## **PLAN REVIEW SHEET**

**Telephone:** 704-353-0018 **Petition:** 2015-103

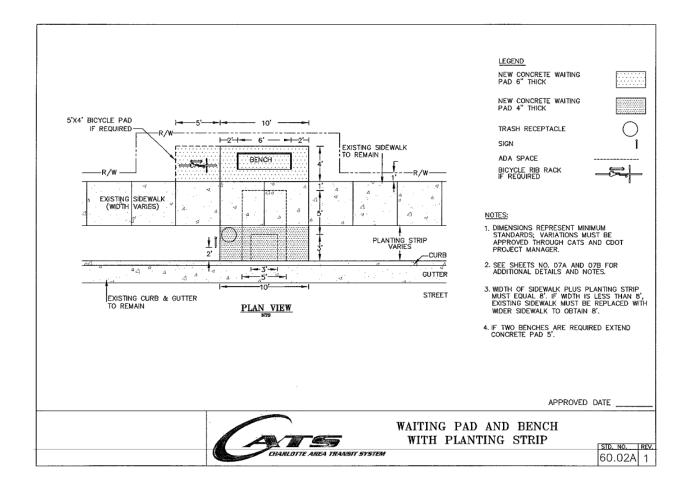
This site is located on a future bus route that will connect to the planned JW Clay Boulevard LYNX Blue Line Station. The Petitioner is requested to provide and construct a bench pad for a new bus stop along Mallard Creek Church Road before the right turn lane. Below is an image of the standard detail (60.02A) for the requested bus stop pad. CATS will be responsible for installation and maintenance of the bench.
